**National Biodiesel Board**

December 5, 2019

Re: Proposed BP Products Tier 2 Co-Processing Pathway Application (No. B0018)

Figure: System boundary for co-processing in hydrotreater.

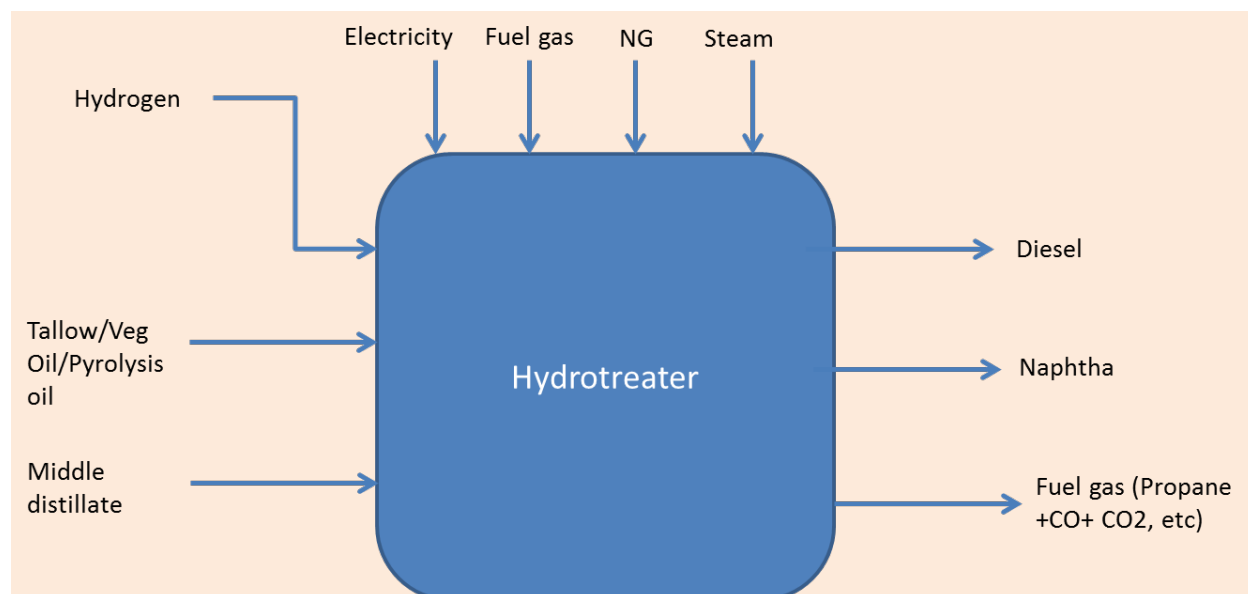
The co-processing calculator that CARB developed, and BP uses, only considers the hydrotreater as shown in this figure from the calculator.

Any energy expended outside of these system boundaries is not included in the co-processing analysis. This excluded energy could include:

1. Electricity for feedstock receiving and shipping tanks.
2. Heat tracing for feedstock tanks.
3. Any energy used for emission control systems and effluent treatment.

It would appear that the system boundaries for co-processing are narrower than the system boundaries for standalone plants and provide an unwarranted CI advantage to co-processing operations.

3. CARB should add some emissions to account for the energy that is consumed by the process that is outside of the system boundaries of the CARB co-processing calculator so that the system boundary is the same as a standalone renewable diesel plant.
4. CARB should add some very tight conditions for the sulfur and nitrogen contents of the VGO when co-processing to the sulfur and nitrogen content of the VGO baseline.
5. CARB should require the applicant to revise all other process inputs and values identified in the comments above as problematic, inaccurate, or otherwise unrealistic.
